PERCOLATION TESTING

**BURNTWOODS**  
 LOTS 4 & 5  
 TAX MAP 21 - SECTION 3 - PART 2 - BLOCK B  
 HOWARD COUNTY, MARYLAND  
 THIRD ELECTION DISTRICT  
**PERCOLATION CERTIFICATION PLAT**

RE: Burntwood, Lots 4 and 5  
Perc Test Plat

RE: Plan Review Comments  
A 511343 A&B  
Burntwoods, Lots 4 and 5  
Map 21, Parcel 110  
Castlebar Drive

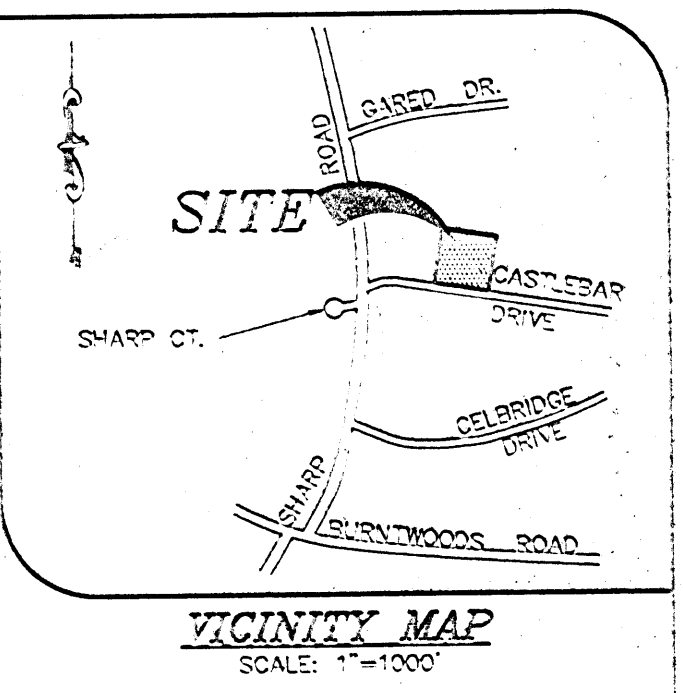
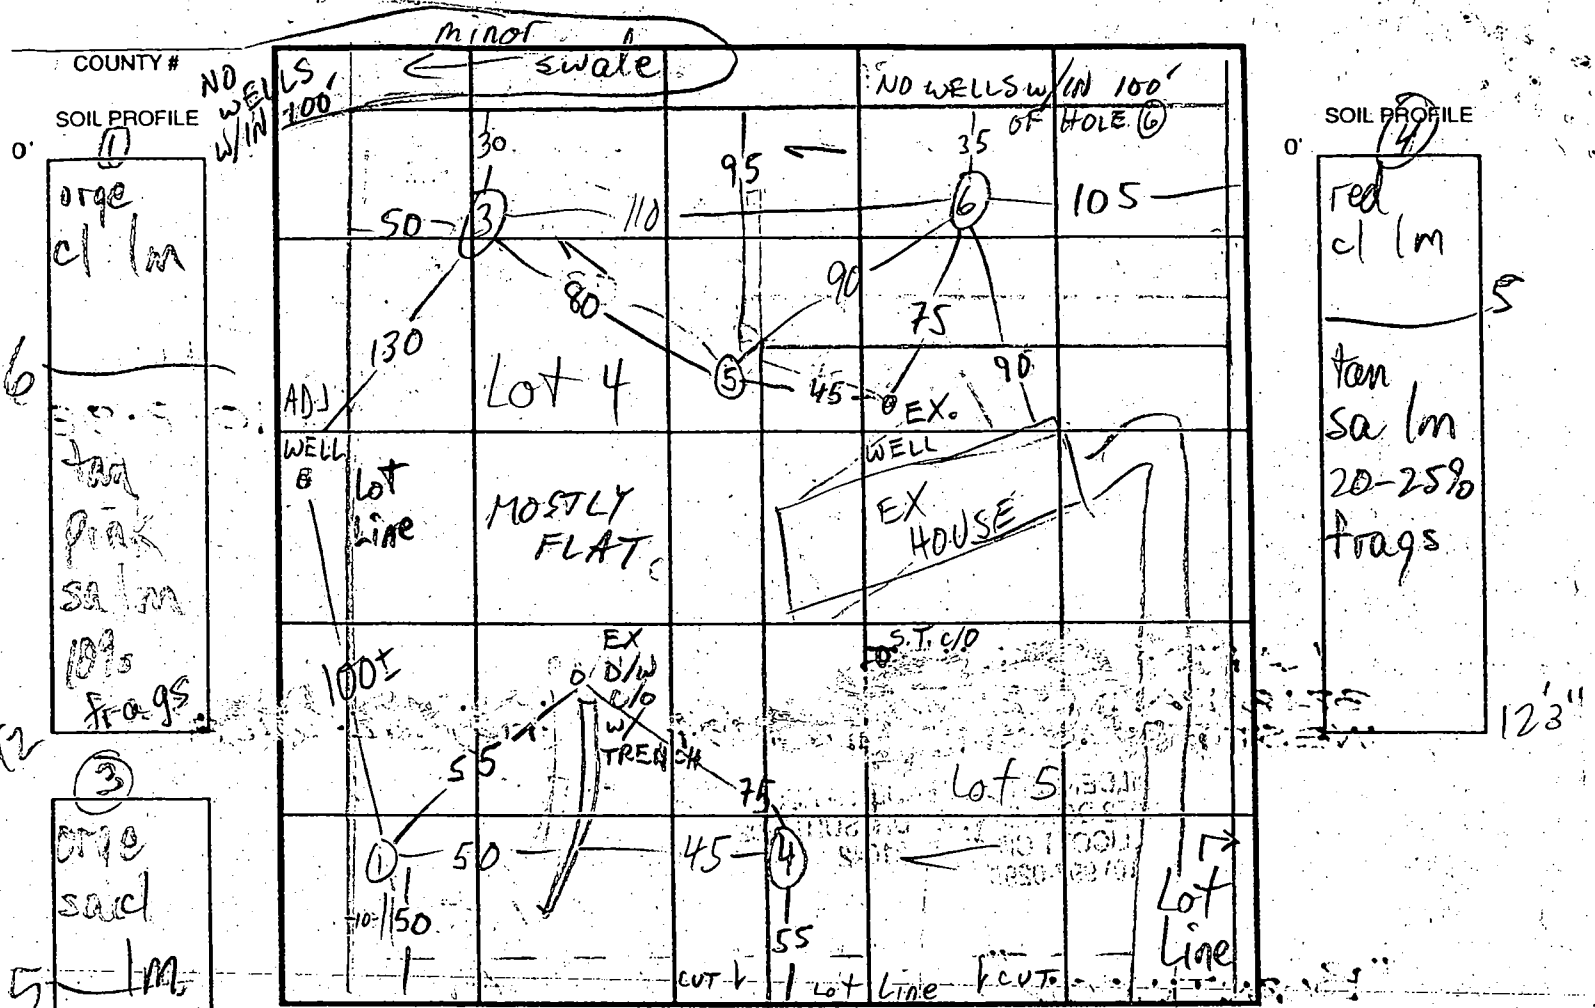
Percolation testing conducted February 1, 1999 at the referenced property indicated satisfactory soil conditions, but the sufficiency of available area for a sewage easement on lot 4 is uncertain. Copies of the test results are enclosed.

Further review is contingent upon submission by a registered engineer of a percolation certification plan showing actual locations and elevations of all excavated test holes and a suitable house and well site. The plat should also include the locations of all existing wells and septic systems on the property as well as the locations of any other relevant features such as streams, swales, or existing structures. A note must be included certifying that all existing wells and septic systems within 100 feet of property boundaries have been shown.

The combination of limited acreage and a well on adjacent lot 3 reduces the likelihood that adequate area is available area for a sewage easement on lot 4. Please be certain that precise locations of all existing wells and septic systems within 100 feet of property boundaries are shown.

The plan should include a note that all new wells will be drilled and the existing well on lot 5 properly abandoned prior to submittal of the record plat for review.

This office has received the referenced percolation certification plan, but is not able to approve it at this time. Serious concerns remain about proposed well locations downhill of proposed sewage easement locations, as well as other issues.

The sufficiency of available area for a sewage easement and a well on lot 4 are uncertain due to limited acreage, a well on adjacent lot 3, a proposed uphill sewage easement on lot 5, and an existing sewage area to the rear.

Because of these concerns it is recommended that the proposal be withdrawn, rather than continue to develop the property under what would be marginal conditions at best.

This revision is in response to your letter dated April 19, 1999, a meeting was held between Mr. Jacob Hikmat and Mr. Craig Willams on April 27, 1999. As per the meeting proposed wells on lot 4 and 5 have been relocated and sufficient septic easements have been provided.

As per our conversation in your office on 7/19/99, the following changes are made on the plan:

1. Revising general note #9.
2. Adding date on the Passed Percolation test legend.
